# Access Compliance Report

## Public Rights-of-Way

Intersection ID: 10018673	Main Street: FRANCES IRENE DR	Cross Street: N/A	Location: SE
ADA ID: F947FDC85262	Ramp Type: Perp	Initial Pass/Fail: Pass	Overall Compliance: No
		Severity Score: 0	
Codes/Mitigation Info/Possible Solution		Field Measurements/Component Compliance

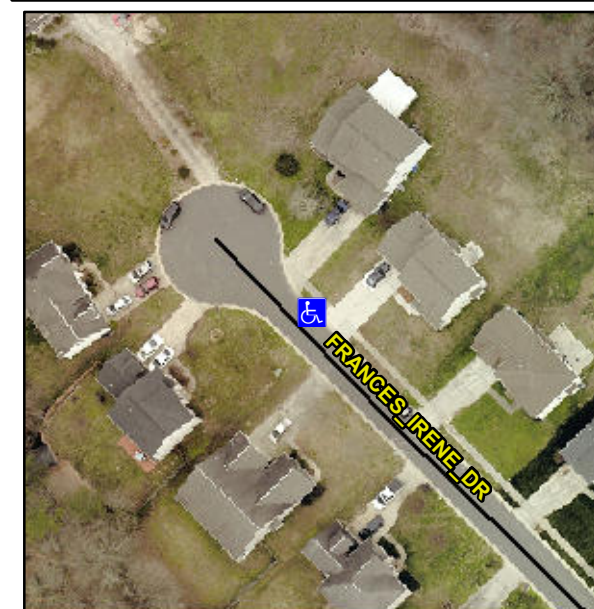
PROW/ADA:

**Not Found, R302.7**

**Remove & Replace Entire Ramp.**
